TileCal ATCA Carrier Base Board:

Design updates for production

Current configuration

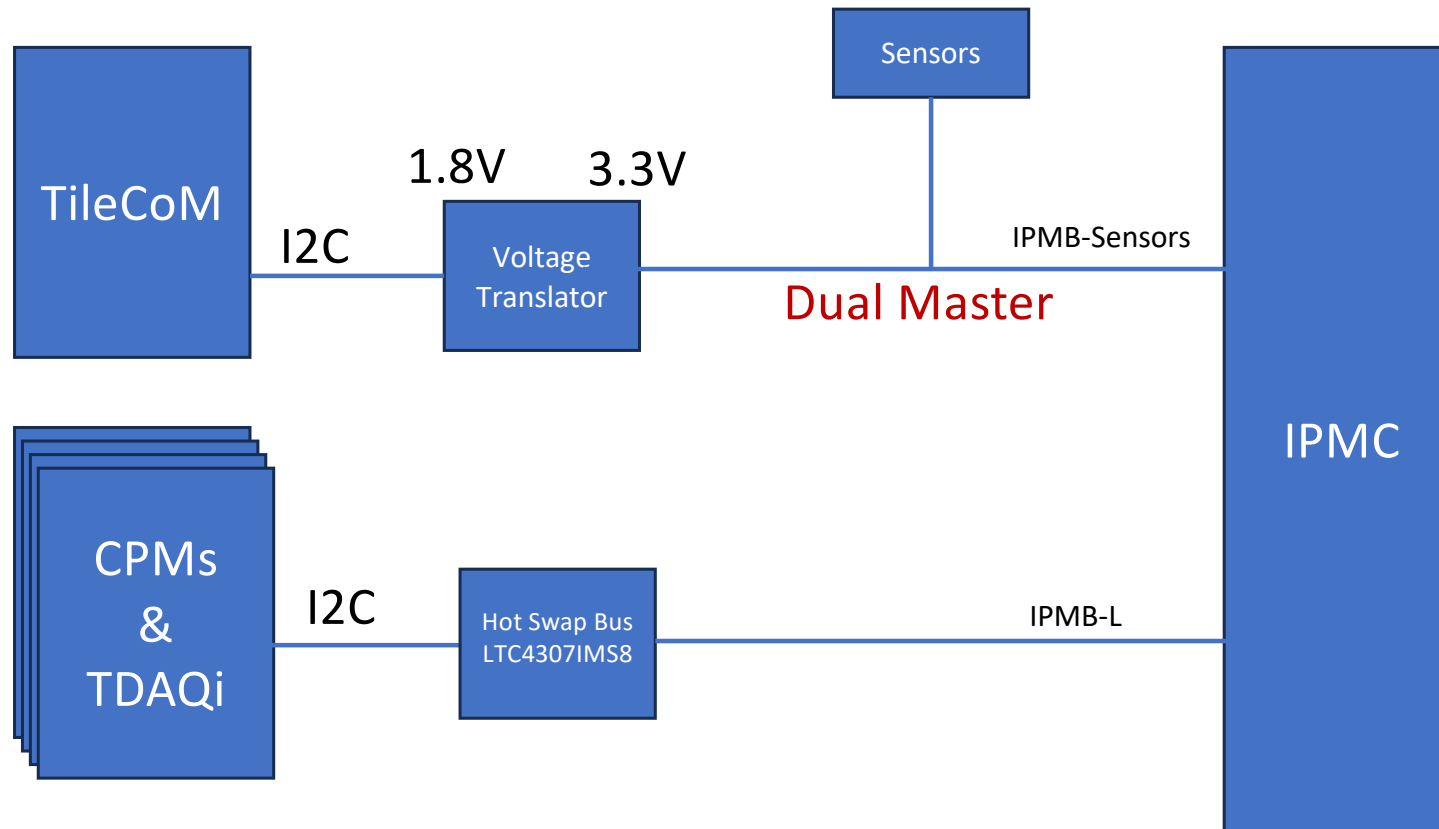
- We have connected the TileCoM and IPMC UART to Zone 2 connector – extra function
 - Currently only possible from two connector in the PCB (not accessible from front-panel)

- Eventually will allow the remote connection from a HUB node
 - Recommendation to remove the dual master in I2C for sensors reading
 - Suggestion was to read the sensors from one of them and then transfer to the second on

- Alternatives:
 - Semaphores
 - Use the TileCoM as a light-FRU (no power negotiation but connection to IPMB-L to send sensors values from IPMC)
